Manuscript **hess-2024-196**: “*Effects of boundary conditions and aquifer parameters on salinity distribution and mixing controlled reactions in high-energy beach aquifers.*”

Author responses to Reviewer #1.

Author responses to Reviewer #2.

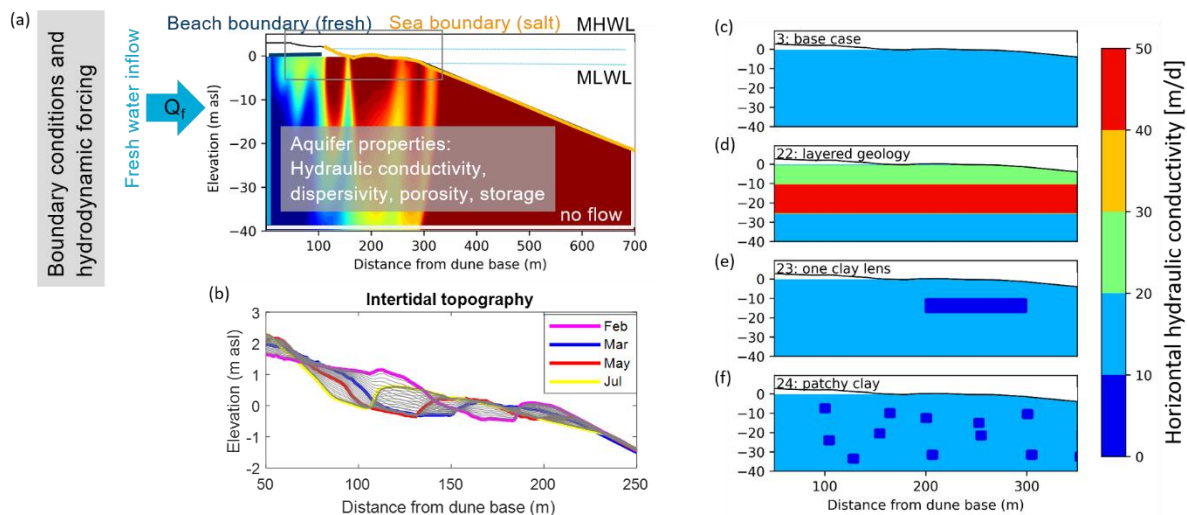
1. It is unclear how the surface interpolation was made, and given that the authors express the importance of this feature in the modeling choice, more information should be provided on this matter. Thus, I recommend adding more information on the methods of how the interpolation was made and refining the plot in Figure 1 so that the reader can picture how beach morphology changes over time.

1. There is a small box in (a) that is not described in the caption. Is this the area where changes in beach morphology occur? If so, I recommend stating it in the caption.

2. Is the hydraulic conductivity presented in (c) through (f) the horizontal ( $K_h$ ) or the vertical ( $K_v$ ) component?

As suggested by the reviewer, Figure 1 was updated to better demonstrate how the intertidal topography changes over time:

AC: The reviewer is right that the box encompasses the area where the variable beach morphology was applied. We will extend the caption of Figure 1 respectively. We included an update to Figure 1 (see above)

Caption of Figure 1: “Figure 1: (a) Model setup with dimensions, boundary conditions and parameters, (colors indicate TDS distribution: red = saline, blue = fresh). The thin grey box encompasses the part of the sea boundary where changes in beach morphology occur. (b) Four LIDAR scans (Grünenbaum et al., 2020a) of intertidal topography (colored lines) and respective interpolated topographies (grey lines show 10-day increments). (c) to (f) Four different geological settings, note  $K_h = 0.005$  m/d for the clay lens and clay patches (dark blue).”

AC: The horizontal hydraulic conductivity is presented in Fig.1 c-f . We added it to the figure's colorbar (see updated Figure 1 above).

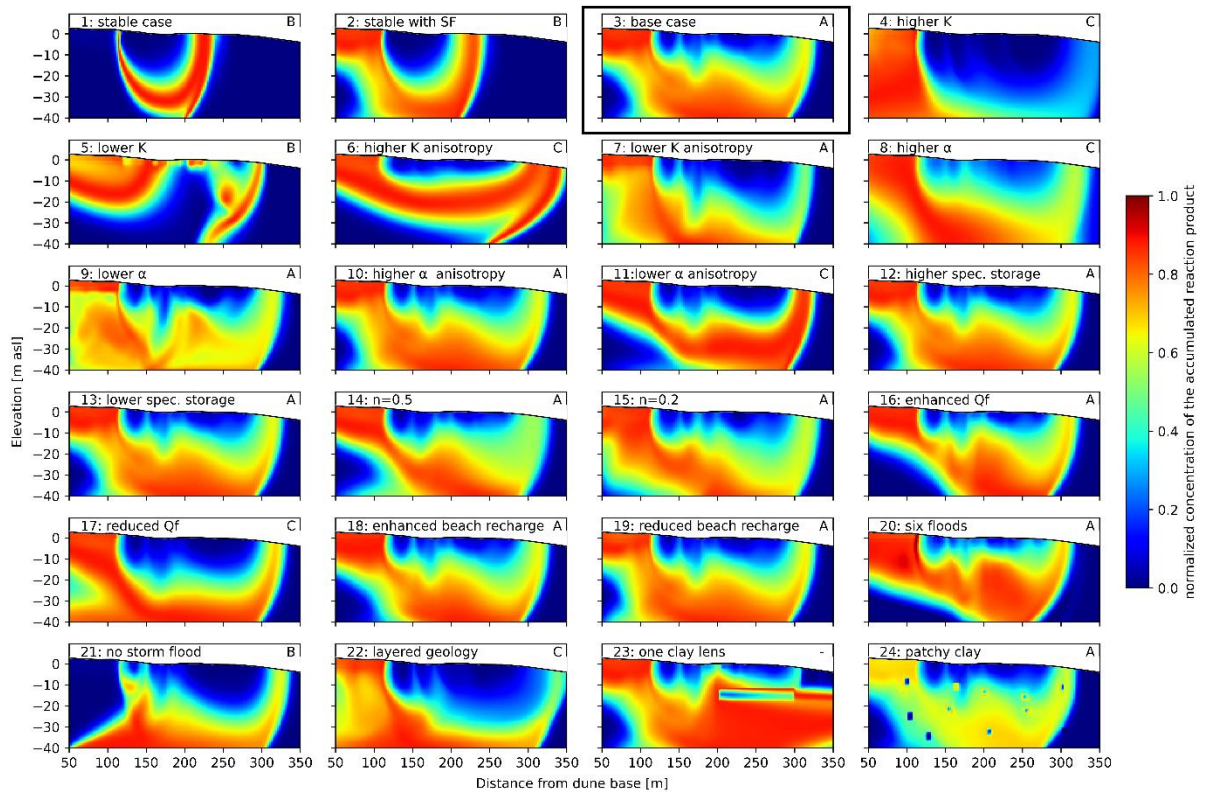
2. Regarding mixing-controlled reactions, the authors used the initial salinity patterns for the  $R_f$  and  $R_s$  concentration patterns. This modeling choice could create misleading mixing patterns because these chemical constituents were assumed conservative, and the model needs to stabilize first. So, did the authors consider warming up the model before setting the initial concentration patterns?

AC: The reviewer is right that the initial distribution of  $R_f$  and  $R_s$  could have had an effect on the final patterns of their mixing product (Mp). In order to resolve this issue, we have now subtracted the accumulated mixing concentration after 10a (when the initial concentrations of TDS did not influenced final salinity patterns any longer) from the final (20a) simulation concentration. The general mixing patterns look very similar to the previous results, as presented in the new Figure 5 (see below). However, slight changes in normalized concentrations are visible (Fig. 5). Therefore, we decided to follow the reviewers recommendations and updated Figure 5 and also re-calculated the cluster analysis (Fig. 6) which also showed slight differences. Moreover, we modified the corresponding text about the cluster analysis. However, the overall changes were only minor and the general picture and conclusion driven are still valid.

Changes to the caption of Figures 3, 4, 5: “The letter in the upper right corner refers to the cluster group (cf. Tab. 1, Fig. 6).”

Figure 6: Cluster analysis (k-means,3) of all model cases based on model variation in salinity ( $\gamma$ ) and the sum of reaction product of each model ( $RP_M$ ). Individual model values were normalized to the base case (located at 1,1 in the plot).

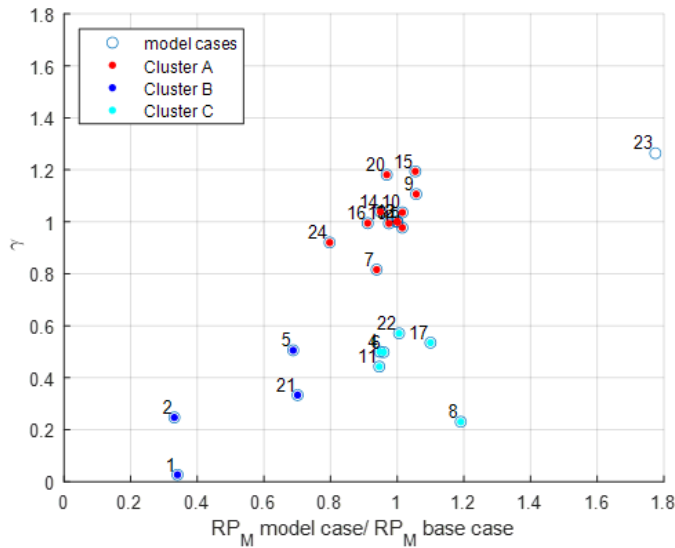
14. I consider the clustering analysis a neat exercise for examining similar models. However, switching between Figure 6 and Figures 3 through 5 can be cumbersome. I recommend adding boxes around the subplots in Figures 3 to 5 that represent the colors of the clusters; that way, it is easier for the reader to visualize which models are clustered together.

Lines 316-323: “A k-means analysis based on  $\gamma$  and  $RP_M$  of each model case normalized to the same statistics of the base case, resulted in the clustering of the model cases into three main groups (Fig. 6, Table 1). Cluster A (red circles) had a  $\gamma$  (+/- 20%) and  $RP_M$  (+/- 20%) similar to the base case (located at the coordinates 1,1 in the diagram in Fig. 6). Cluster B included the less dynamic and more stable cases with a lower  $\gamma$ , reduced by 40-98%, and lower  $RP_M$ , reduced by 30-70%, compared to the base case. Cluster B contained the cases with either changing topography only (and no storm floods, case 21) or only storm floods (and no changing topography, case 2) or neither (case 1) and the low K case (case 5). Cluster C was characterized by a lower  $\gamma$  reduced by 40-80%, while keeping a  $RP_M$  (+/- 20%) similar to the base case. One outlier, case 23 with one clay layer, showed a significantly higher  $\gamma$  and higher  $RP_M$  compared to the base case.”

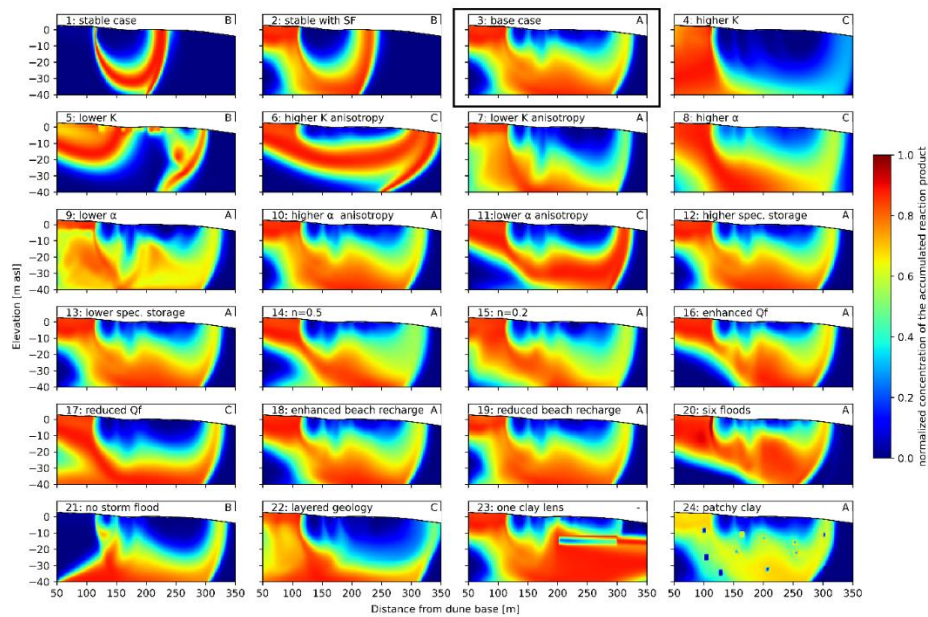
153-154 It seems like the initial distribution of the reactants is unrealistic given that there was no spin up to a steady-state salinity distribution. This should be mentioned as a limitation.

Line 193-195 I am confused by Figure 5 case 3. How is it normalized? If it is normalized to the base case then there should be no variation in the base case figure. A description of the normalization should be included in the methods.

The reviewer is right that the initial distribution of  $R_f$  and  $R_s$  could have had an effect on the final patterns of their mixing product (Mp). In order to resolve this issue, we have now subtracted the accumulated mixing concentration after 10a (when the initial concentrations of TDS did not influenced final salinity patterns any longer) from the final (20a) simulation concentration. The general mixing patterns look very similar to the previous results, as presented in the new Figure 5 (see below). However, slight changes in normalized concentrations are visible (Fig. 5). Therefore, we decided to follow the reviewers recommendations and update Figure 5 and also re-calculated the cluster analysis (Fig. 6) which also shows slight differences. Moreover we modified the corresponding text about the

AC: We understand the necessity for clarification of the normalization procedure that yields the concentration illustrated in Figure 5. The concentrations of the accumulated reactant are normalized to the maximum reactant concentration ( $M_p$ ) across all model versions. We provided a more comprehensive description of the normalisation in the methodology section.

**Figure 6: Cluster analysis (k-means,3) of all model cases based on the models' variation in salinity ( $\gamma$ ) and the sum of reaction product of each model ( $RP_M$ ). Individual model values were normalized to the base case (located at 1,1 in the diagram).**

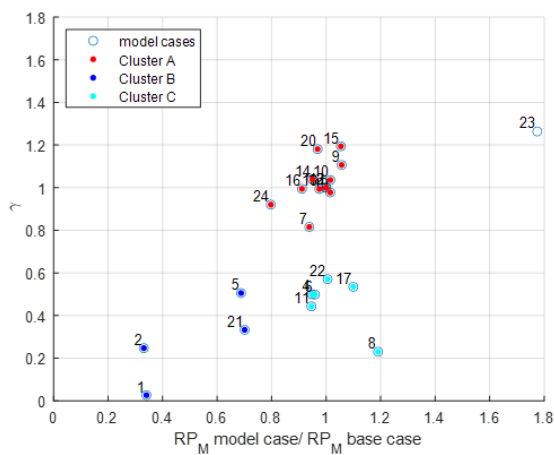
Line 289 Where is the black cross?

Figure 6 Some of the points are hard to see. It would be helpful if the scenarios were labeled so that each number could be read.

AC: The reviewer is right there is no black cross. We removed it and modified the caption of Figure 6

Update caption Figure 6: “Figure 6: Cluster analysis (k-means,3) of all model cases based on model variation in salinity ( $\gamma$ ) and the sum of reaction product of each model ( $RP_M$ ). Individual model values were normalized to the base case (located at 1,1 in the plot).”

AC: We understand the need for a better recognition of model cases related to the cluster analysis. Reviewer #1 made a similar comment, so we decided that we will add the Cluster groups (A,B,C) to the respective subfigure in Figures 3 to 5 which are also mentioned in Table 1.
